## Environmental Impact Assessment (EIA), scoping phase, on lifetime extension Loviisa 1&2

Organisation: Verein Lebensraum Waldviertel

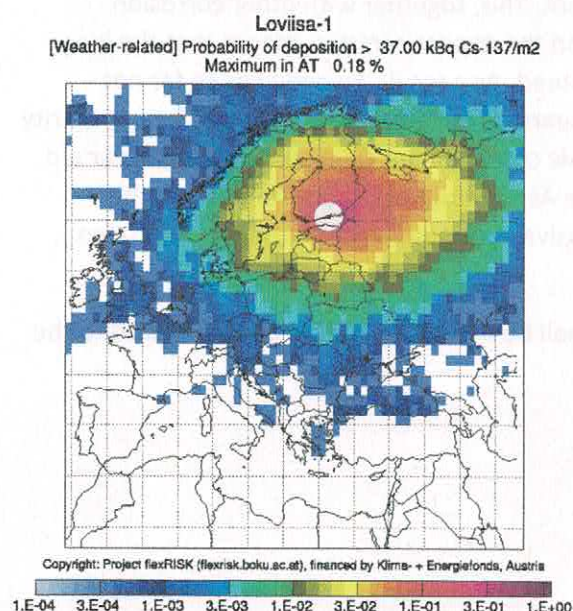
The research project flexRISK shows that a steam generator tube rupture accident in Loviisa unit 1 or 2 could release up to 30% of the radioactive inventory, that is 31.5 PetaBecquerel Cs-137.

The following flexRISK figure shows the weather-related risk for Europe to be contaminated with Cs-137 above 37 KiloBecquerel Cs-137 per m<sup>2</sup> in case of such an accident happening.

**Under unfortunate weather conditions, almost every country in Europe could suffer such a high Caesium contamination.,**

The EIA Report shall also include accident calculations with the highest source term for which the risk is not zero, and dispersion calculations for all of Europe.
